**NHTSA Recall No. 24V-934
Cummins Campaign #C5807**

IMPORTANT SAFETY RECALL

This notice applies to your Cummins Power Generation C275D2RE Generator Sets listed in the table on the enclosed generator set list.

Figure 1: Inspection Location on Generator Set

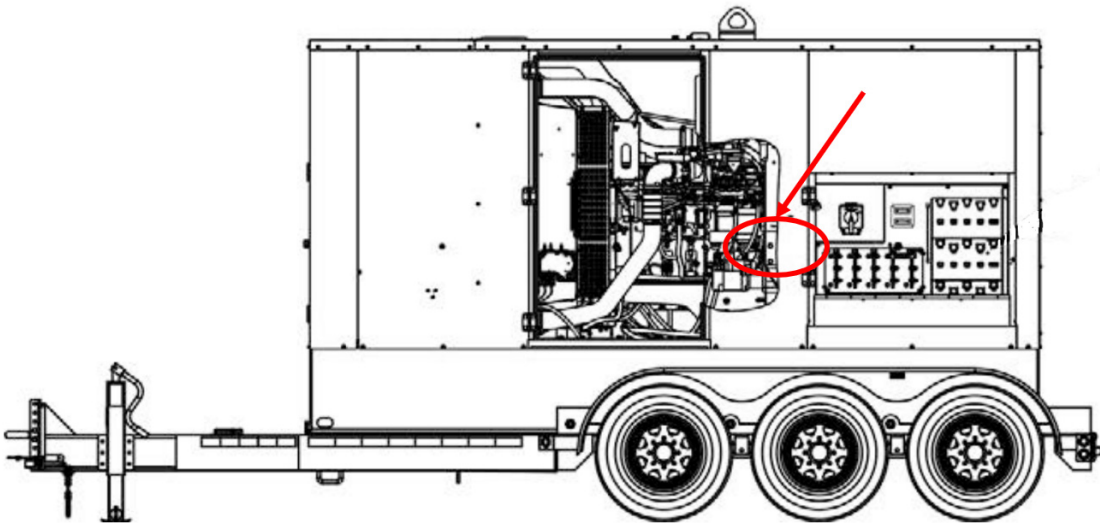
3. Locate the engine's starter motor and inspect the nearby red wires with fuse holders outside of the protective loom for signs of chafing or damage. The inspection location is illustrated in Figure 1.

Figure 2: Example of exposed red wires touching the terminal stud of the starter motor, and resulting chafing damage

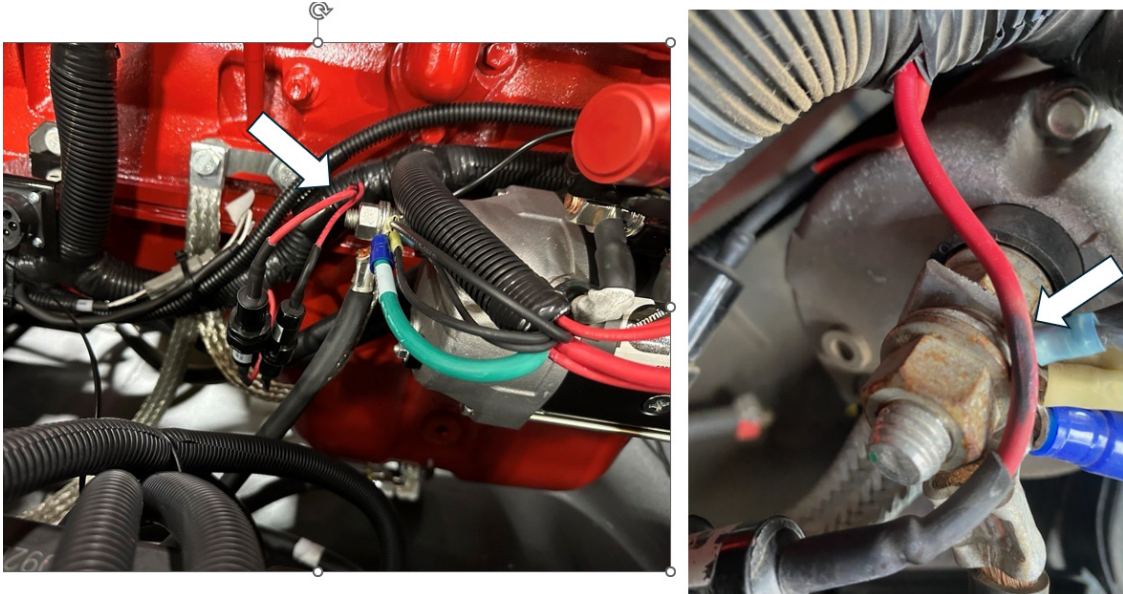
4. If the red wires are touching the housing or terminal stud of the starter motor, or if the red wires show signs of chafing or damage, DO NOT use the unit until repaired by a certified Cummins repair facility. An example of the exposed red wires touching the terminal stud of the starter motor, and the resulting chafing damage to the wire insulation, is shown in Figure 2. An example of the exposed red wires touching the housing of the starter motor is shown in Figure 3.
